Access Compliance Report Public Rights-of-Way (Curb Ramps)

Intersection ID: 4752 Main Street: EVANSHIRE_DR Cross Street: TRINITY_RD Location: W

ADA ID: F875E53B2A61 Ramp Type: Combination1 Initial Pass/Fail: Fail Overall Compliance: No Severity Score: 18.75

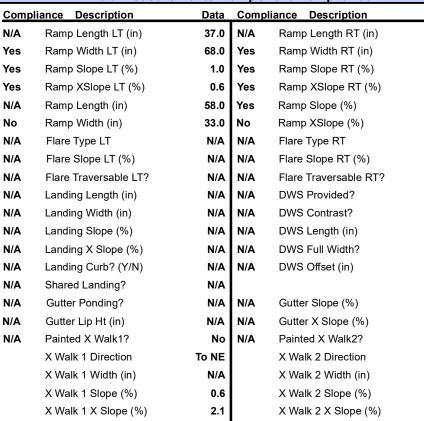
RP & LT RP < 5%

Not Found, R304.5.1, R304.5.3

Remove & Replace Entire Ramp.
